REVISED CLEANUP PLAN SOUTH PLANT SITE

Trinity Industries, Inc.
Greenville, Pennsylvania

VOLUME 2 OF 4

**RE: RESPONSE TO COMMENTS
CLEANUP PLAN-SOUTH PLANT SITE - DISAPPROVAL
TRINITY INDUSTRIES, INC. FACILITY ID NO. 731732
BOROUGH OF GREENVILLE, MERCER COUNTY**

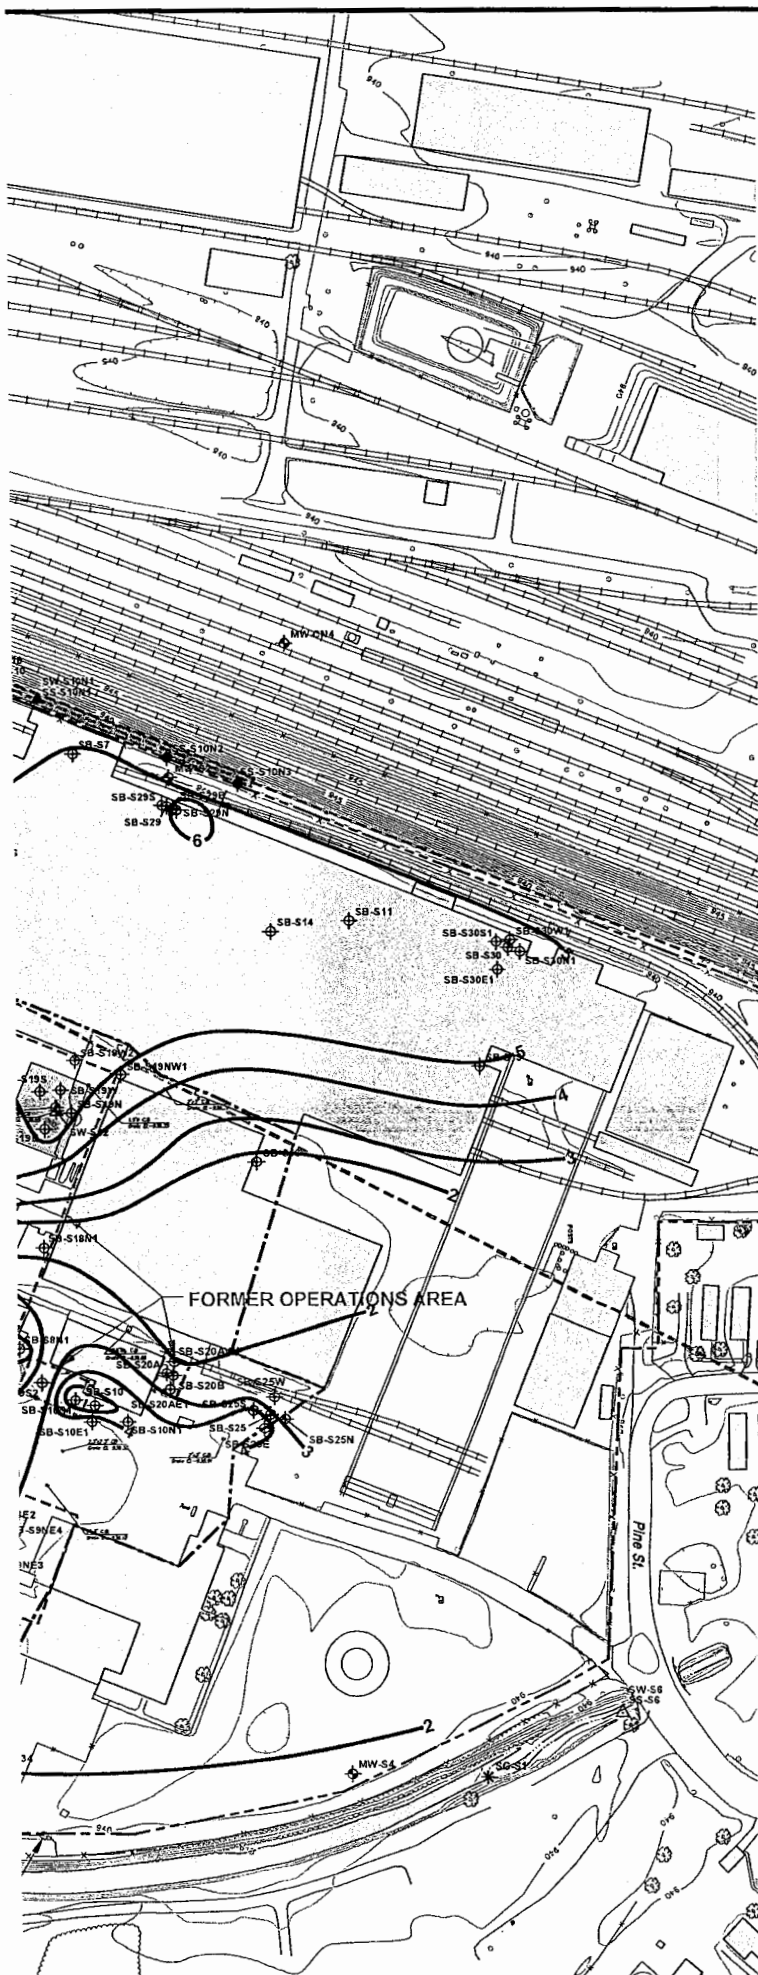
As indicated in previous submissions to the Department, most of this site contains fill consisting of waste process sand. In several sections of the Cleanup Plan it is stated that the Act 2 Statewide Health Standard (SHS) would be applied to this waste process sand. The SHS is available for soil and groundwater media only. If the waste process sand is non-hazardous and its placement occurred prior to September 7, 1980, closure of the site-wide waste process sand areas can be addressed through demonstrating an Act 2 Site-Specific Standard in accordance with 250 Subchapter D. This may be done through capping and/or excavation to achieve pathway elimination utilizing the Act 2 SHS Medium Specific Concentrations (MSCs) to determine the limits of capping and/or excavation. Under this scenario, Act 2 relief from liability would be limited to the area capped or excavated. Alternatively, Trinity may elect to address the site-wide waste process sand by demonstrating that it meets a risk-based

Figure 1A (see attachment) shows the depth and extent of fill across the Site. This figure shows a clear distinction between grading fill used to level the Site for development and the historic disposal areas (i.e., waste process sand disposal area and the Old Ballfield area).

FIGURE 3

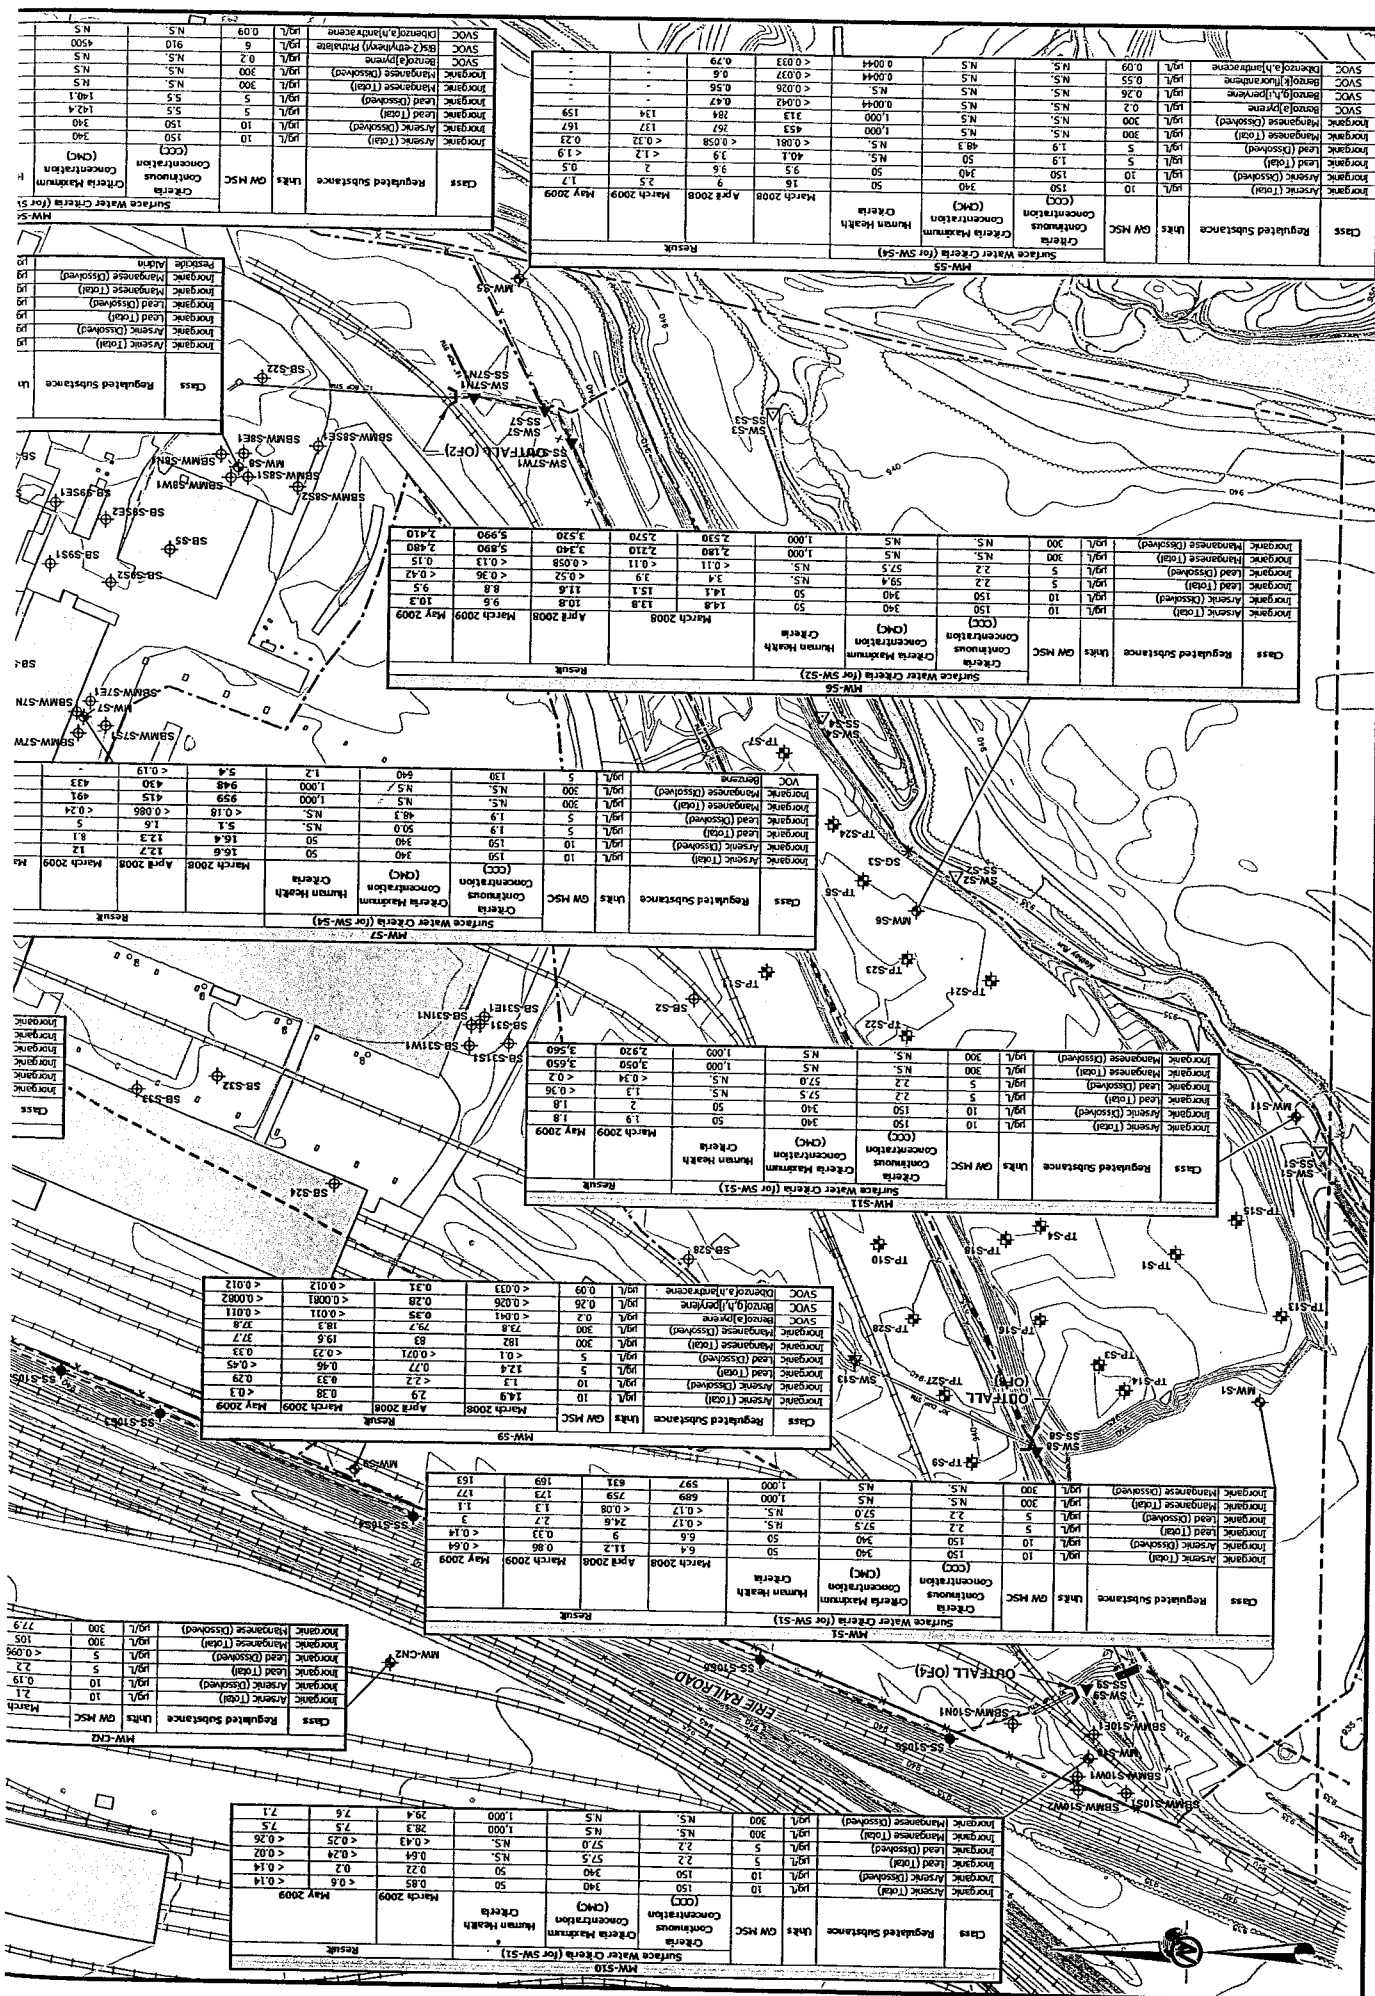
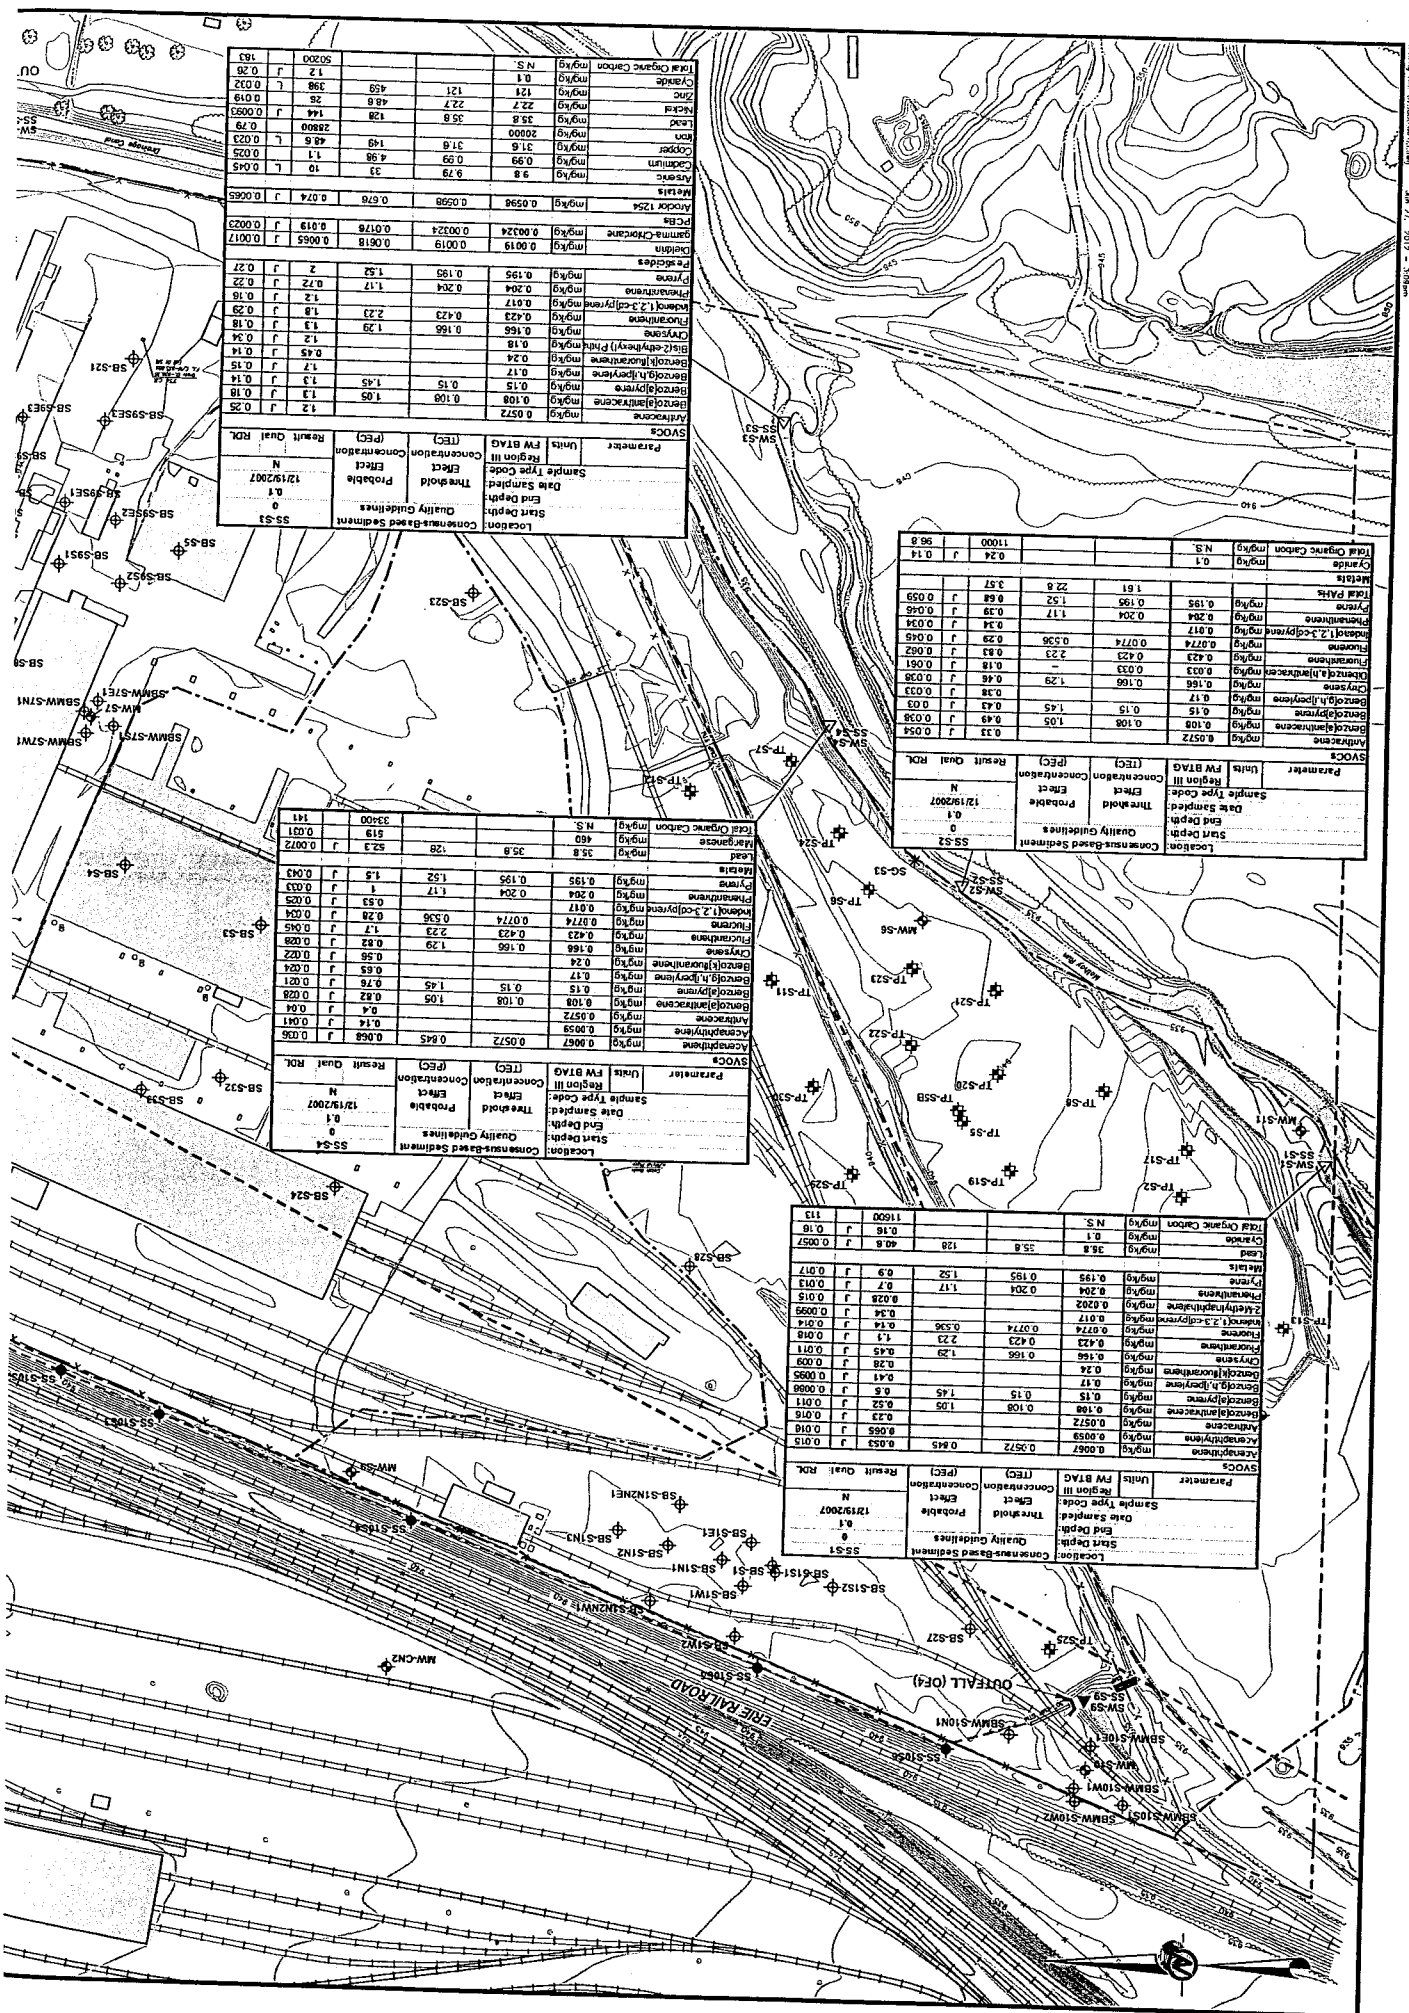
The 2011 "Clean Up Work Plan-South Site" concluded that sediments impacted above the United States Environmental Protection Agency, Region 3, Biological Technical Assistance Group, Freshwater Sediment Screening Benchmarks, may be site related (detections of contaminants found in sediments correlate to AOC-S3 for lead, manganese, and zinc), Trinity now concludes in the Cleanup Plan that the impacts to sediments are not 'site-related' and are likely related to off-site impacts. However, Trinity had a National Pollutant Discharge Elimination System (NPDES) permit (No. PAR808323) for discharge to Erie Extension Canal for Outfalls No. 1, No. 2, and No. 3. It is noted on the NPDES application that these outfalls drained approximately 55 acres of the facility to the Erie Extension Canal. Additionally, Trinity Industries-North Plant Site's stormwater discharges into the Old Erie Canal, as noted by Trinity in their "Response to Comments & Revised RI Report-North Plant" letter dated September 2, 2011. Therefore, Trinity will need to address the sediment impacts in accordance with 25 Pa. Code §§250.311 and 250.402, as well as the guidance provided in Section IV.H of the Land Recycling Technical Guidance Manual.

For sediments in the Old Erie Canal and Mathay Run, the RI data (see attached Figure 3) show that the majority of Constituents of Concern (COCs) exceeding the United States Environmental Protection Agency (USEPA) Region III Biological Technical Assistance Group (BTAG) screening criteria are polycyclic aromatic hydrocarbons (PAHs), polychlorinated biphenyls (PCBs), pesticides, and metals that are not COCs at the Site (see attached Figure 3). In addition, the upstream samples at locations SS-3 and SS-6 show similar exceedances, indicating that the COCs are related to off-Site anthropogenic sources associated with urban stormwater runoff. Furthermore, stormwater evaluations, including dye studies, performed in July 2011 as part of the pre-design investigations showed that there are no direct stormwater discharges from the Site to the Old Erie Canal. Therefore, a baseline risk assessment for sediments for either human health or ecology should not be required as part of this Cleanup Plan.

less conservative. The data and the screening criteria are shown on attached Figure 3. When the sediment data are compared to the less conservative PECs, exceedances remain at location SS-S5 as well as upstream sample locations SS-S3 and SS-S6 for parameters including PAHs, gamma-chlordane, lead, and zinc.
